BRUNSWICK STEAM ELECTRIC PLANT, UNIT NOS. 1 AND 2  
DOCKET NOS. 50-325 AND 50-324/LICENSE NOS. DPR-71 AND DPR-62  
REQUEST FOR LICENSE AMENDMENTS - PERFORMANCE BASED NUCLEAR  
ASSESSMENT PROGRAM

**BRUNSWICK STEAM ELECTRIC PLANT, UNITS 1 AND 2  
NRC DOCKET NO. 50-325 AND 50-324  
OPERATING LICENSE NOS. DPR-71 AND DPR -62  
REQUEST FOR LICENSE AMENDMENT  
PERFORMANCE-BASED NUCLEAR ASSESSMENT PROGRAM**

**SUMMARY OF PROPOSED CHANGES AND  
BASIS FOR EACH CHANGE REQUEST**

## Proposed Nuclear Services Department Organization

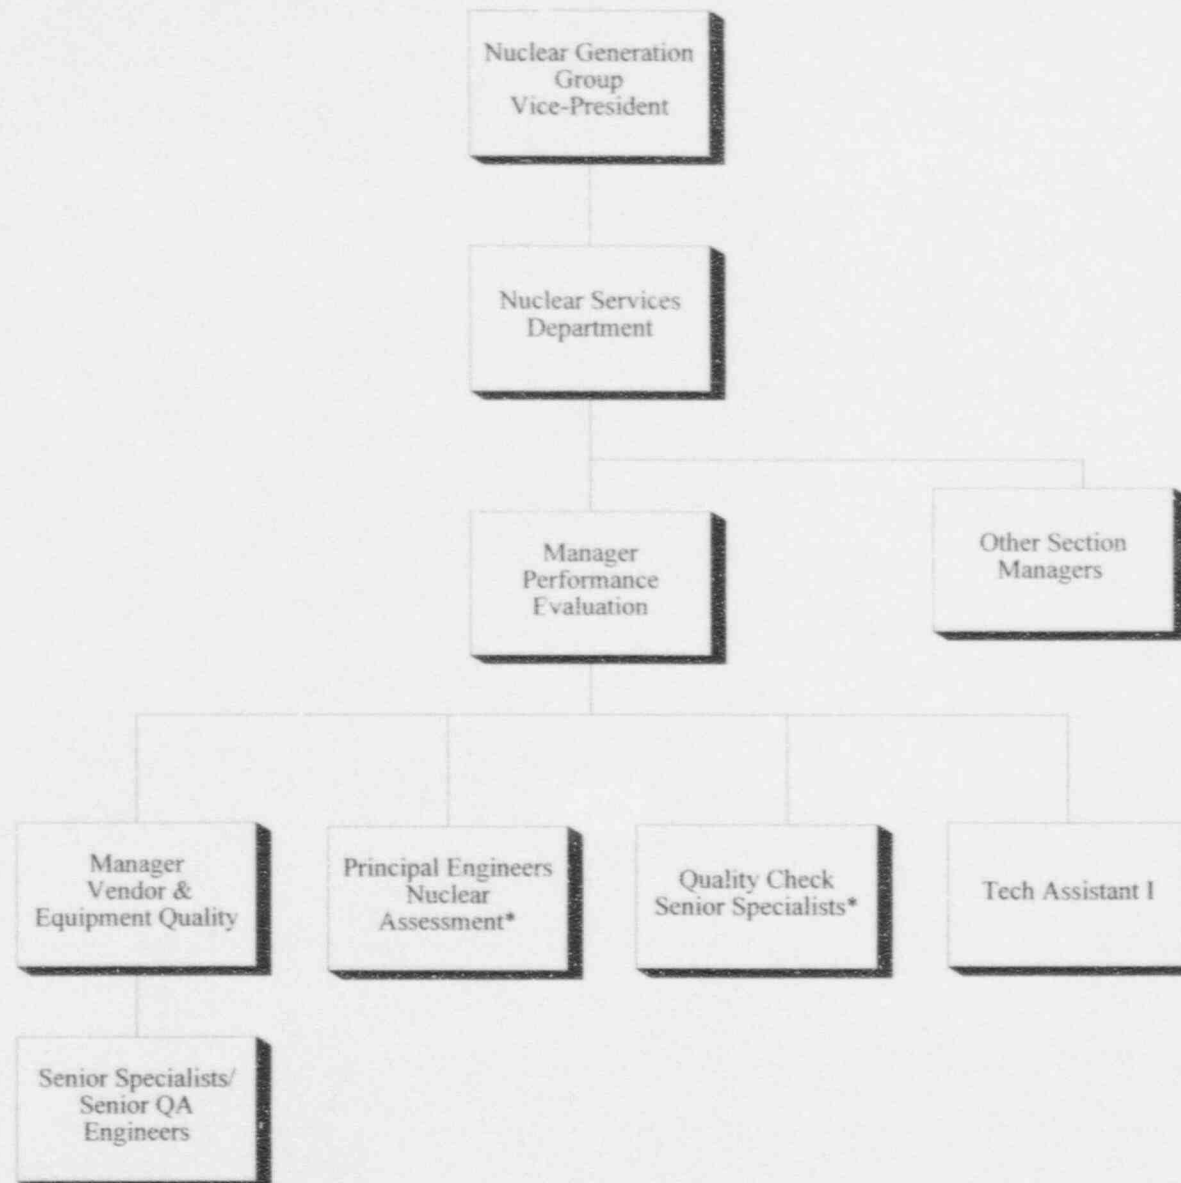
The current Vendor and Equipment Quality function and the Quality Check (employee concern) program will be reassigned from the NAD to the NSD, where it will report to the Manager-PES. The realignment of corporate functions and reporting relationships are shown in Attachment 1A.

## BNP Proposed Nuclear Assessment Section

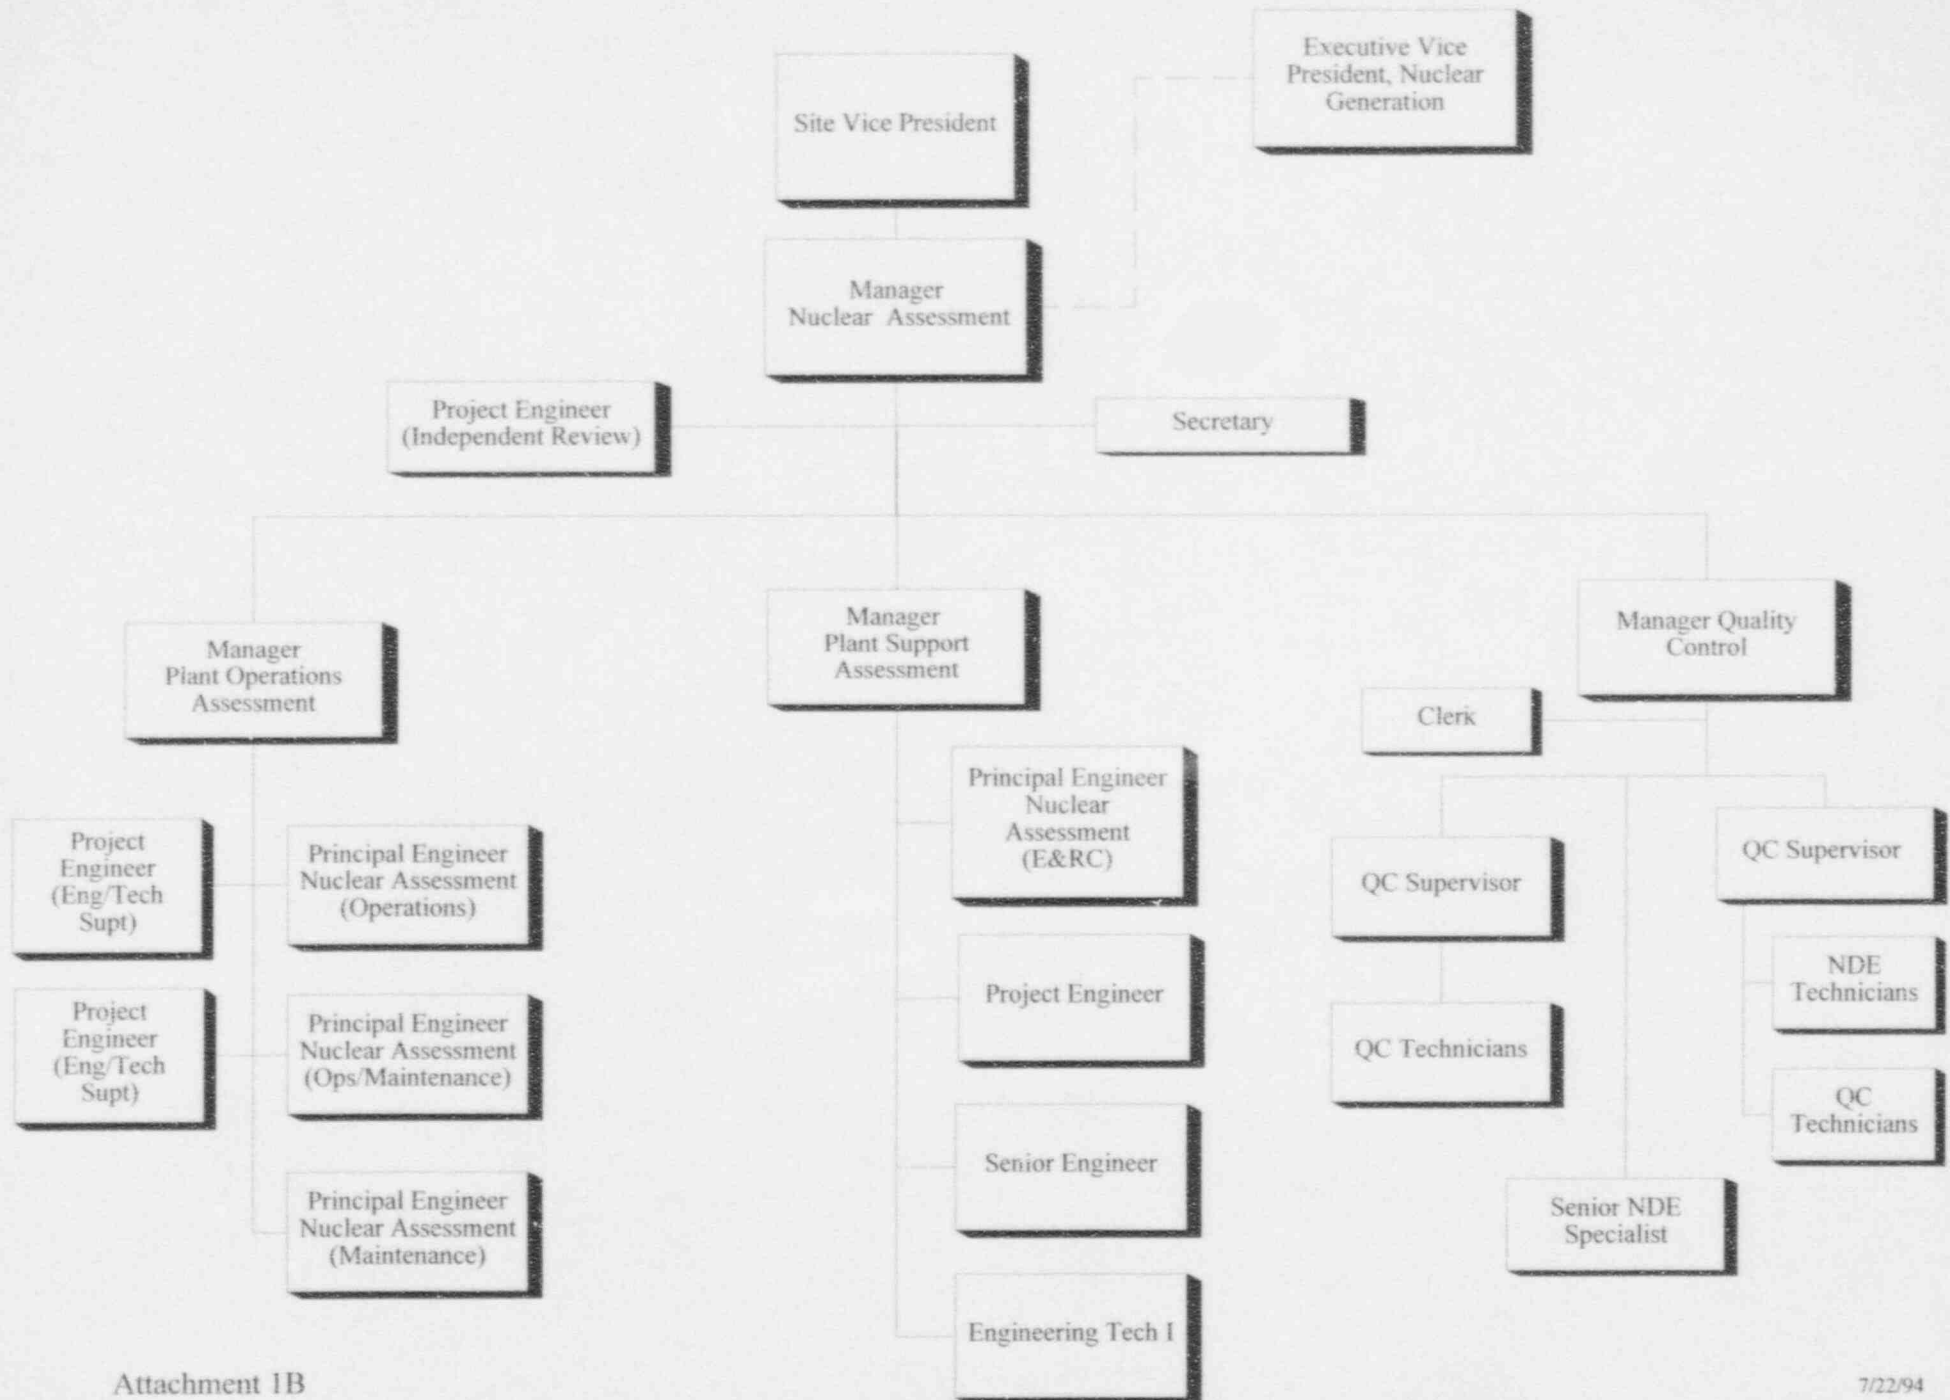
The NAS has been aligned consistent with the current NRC Systematic Assessment of Licensee Performance (SALP) categories. The NAS organization is provided for your information in Attachment 1B. The responsibilities for the Plant Operations and Plant Support Units are discussed below:

- Plant Operations - responsible for Operations, Maintenance, and Engineering and Technical Support.
- Plant Support - responsible for Environmental and Radiation Control and other support areas such as Emergency Preparedness, Security, Document Control, and Material Control.
